Sketch of “pull tab” proposal.

G. Visser IU 11/20/2020

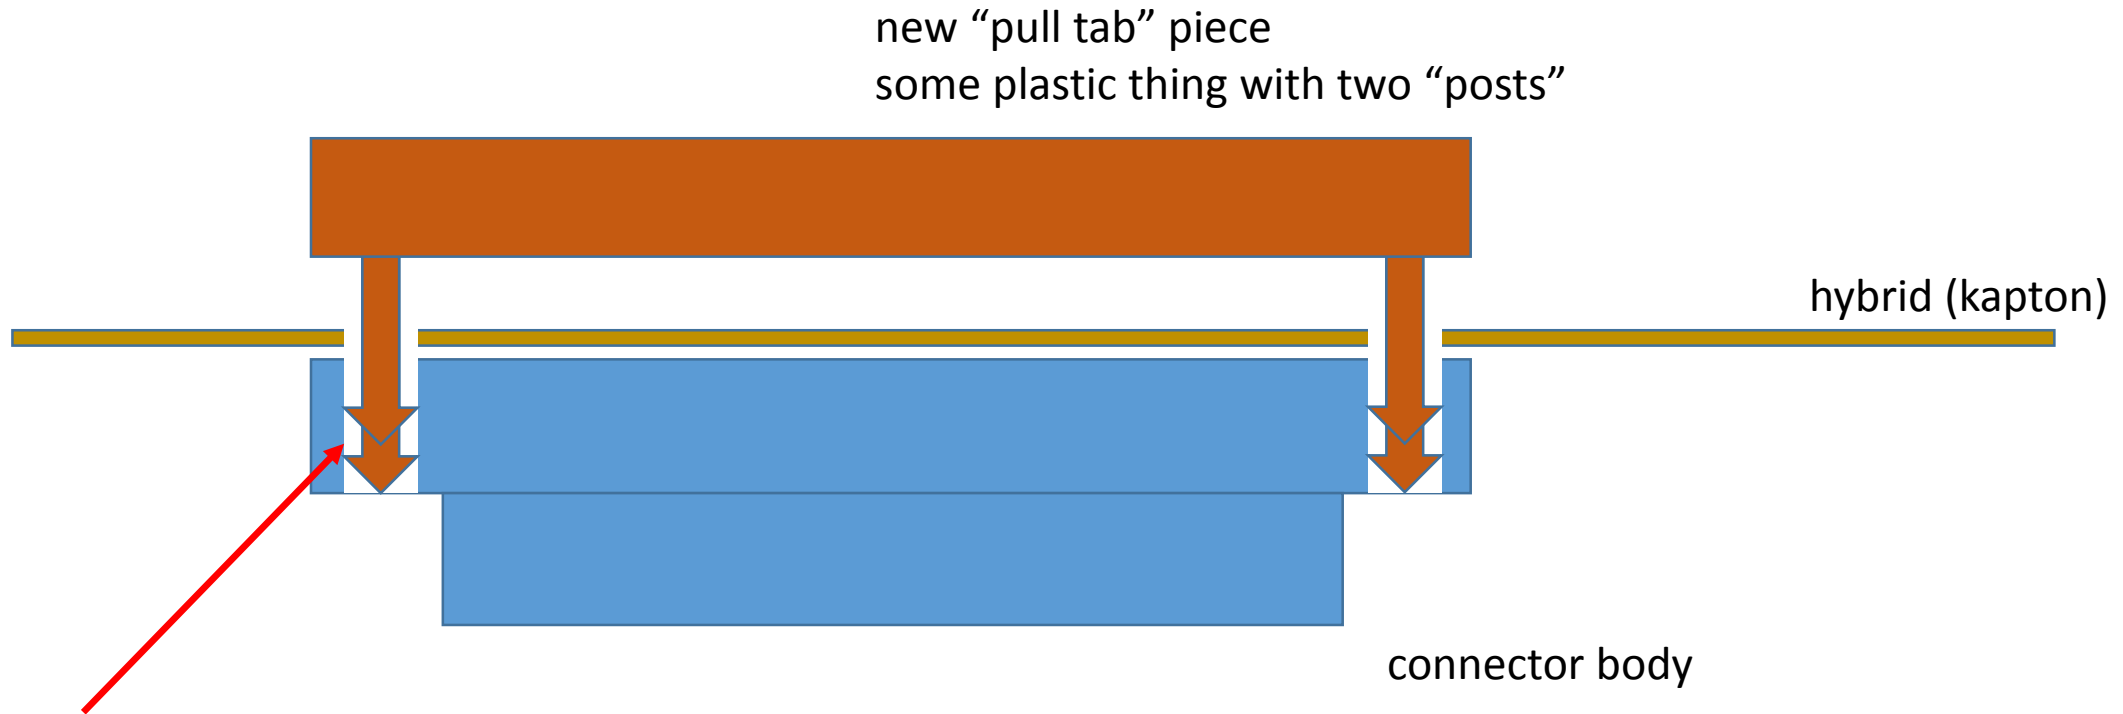
To unmate (and maybe to mate?) the connectors without applying force to the kapton / traces / solder connections.

Secure the “posts” into former screw holes in connector body using some epoxy. Of course, done *after* the connector soldering.

*I will perhaps prototype this next week on FST01 module at IU (if Zhenyu says OK?)*
